Delegated Report

Householder Planning Application

Planning Application No: 20241047

Description: Erection of a single storey front, side and rear extension including a front porch with alterations to fenestrations.

Plans as per Previous Application 20240528

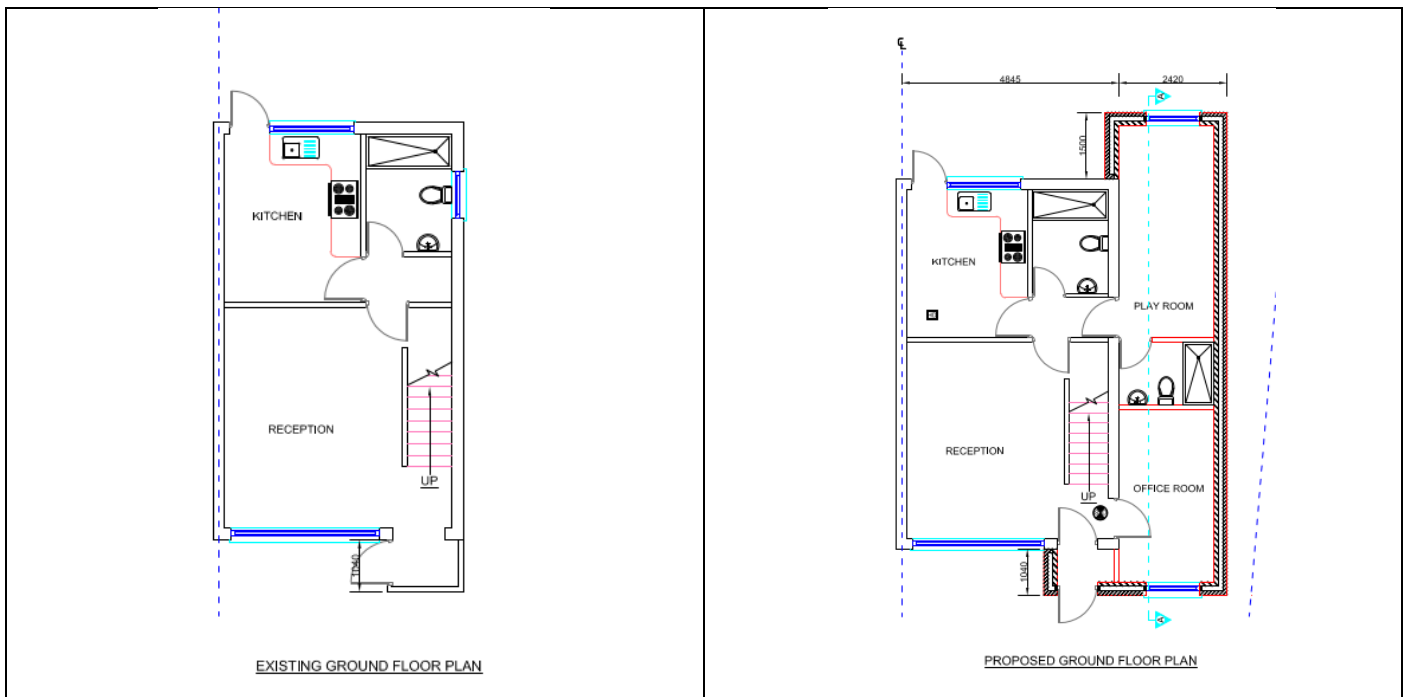
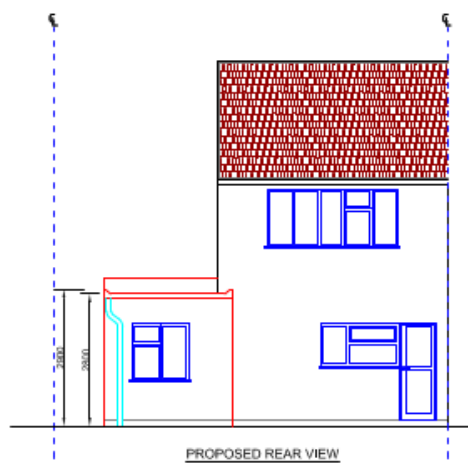
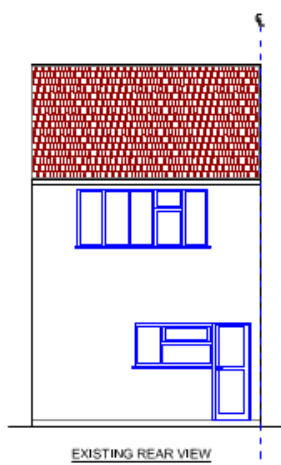
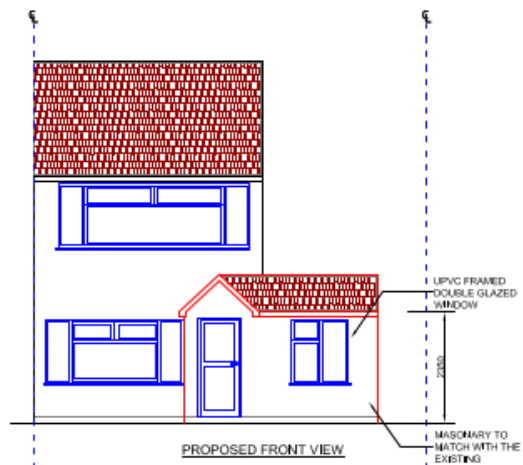
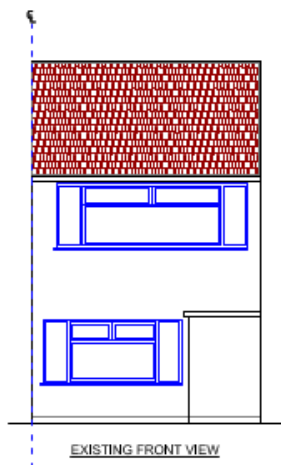
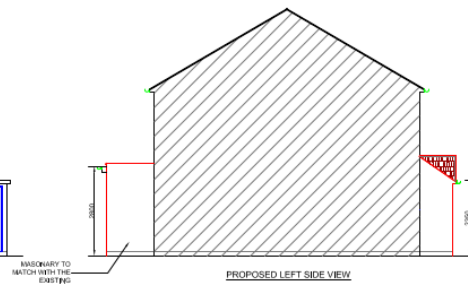
It is noted that following the refusal of the previous application, the side extension has been reduced in width, and is now set away from the site boundary, which is desirable. However, the overall design and scale of the proposal remains contrary to the Design Guide (2021). Gravesham's Householder Design Guide (2021) sets out the design expectations for single storey extensions within the Borough:

Although the proposed extension is single storey, it remains to be excessive in overall scale, bulk and massing and would have an unbalancing effect that would result in an incongruous and dominant addition

to the existing dwelling. This is further emphasised by the proposed extensions (largely) flat roof, along with being set forward of the main front building line and extending back beyond the rear elevation of the existing dwelling. It is noted that, post refusal of the previous application, the front roof design has been altered in an attempt to soften the appearance of the development, however, this is not considered to be successful. The property is situated on a corner plot and, in situ, the roof forms are highly visible from the surrounding area. As such, it is highly important for extensions to be designed to be sympathetic and subordinate to the existing dwelling and to integrate well with the surrounding area.
